REQUEST

Current Zoning: R-3 (single family residential)
Proposed Zoning: B-2(CD) (general business, conditional)

Approximately 10.44 acres located on the west side of Reames Road, south of West W.T. Harris Boulevard.
(Council District 2 - Harlow)

The petition proposes to allow up to 29,600 square feet of commercial uses (including retail with fuel sales), a hotel with up to 125 rooms, and dedication of land for greenway purposes on a site located south of Northlake Mall.

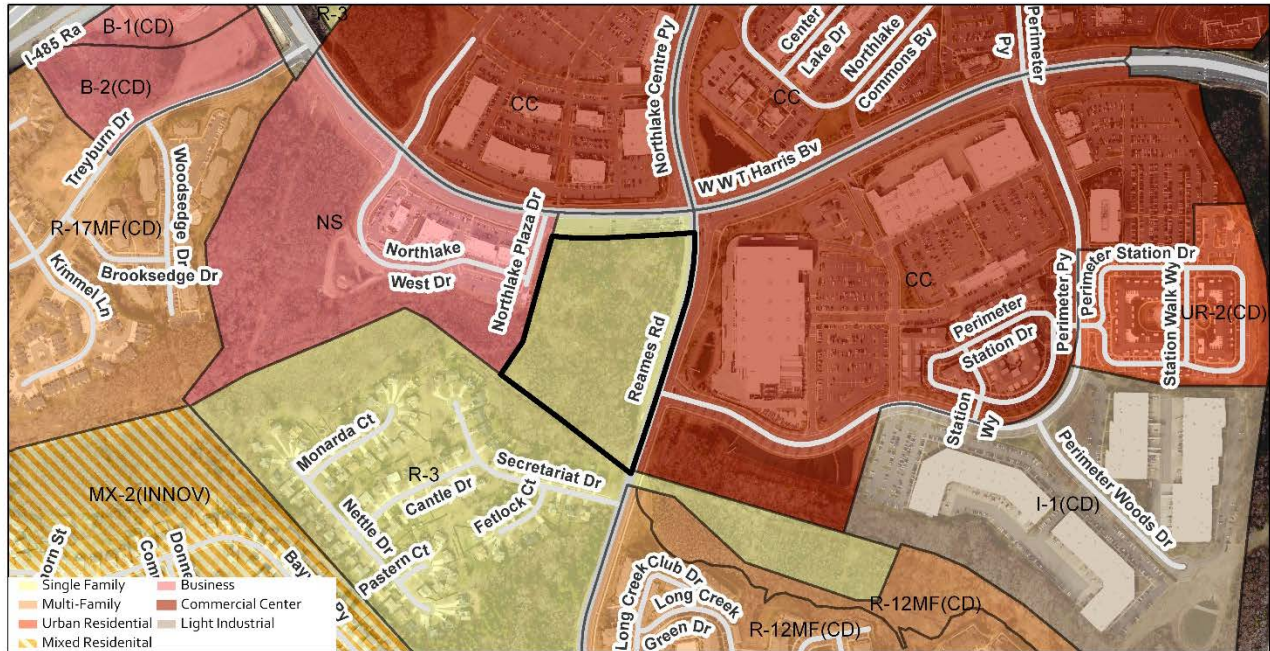
- Intersection of W.T. Harris Boulevard and Reames Road:
 - Restripe existing eastbound W.T. Harris Boulevard right turn lane to a shared through/right lane extending to Northlake Plaza Drive.

- Intersection of West W.T. Harris Boulevard and Northlake Plaza Drive:
 - Restripe the existing eastbound West W.T. Harris Boulevard right turn lane to a shared through/right lane.

- Intersection of Reames Road and Access A:
 - Construct a southbound Reames Road right turn lane.
 - Construct Access A with one egress and one ingress lane.

- Intersection of Reames Road and Perimeter Parkway/Access B:
 - Construct Access B with one egress and one ingress lane.
 - Construct a concrete median to restrict access to right-in/right-out/left-over.

- Construct a pedestrian refuge to maintain access.
 - Construct a northbound left turn lane.
 - Remark the southbound through drop lane as a right turn drop lane.

- Installation of a traffic signal.
 - Installation of fiber optic along Reames Road between West W.T. Harris Boulevard and Access B.
 - Installation of a camera at Reames Road and Access B.
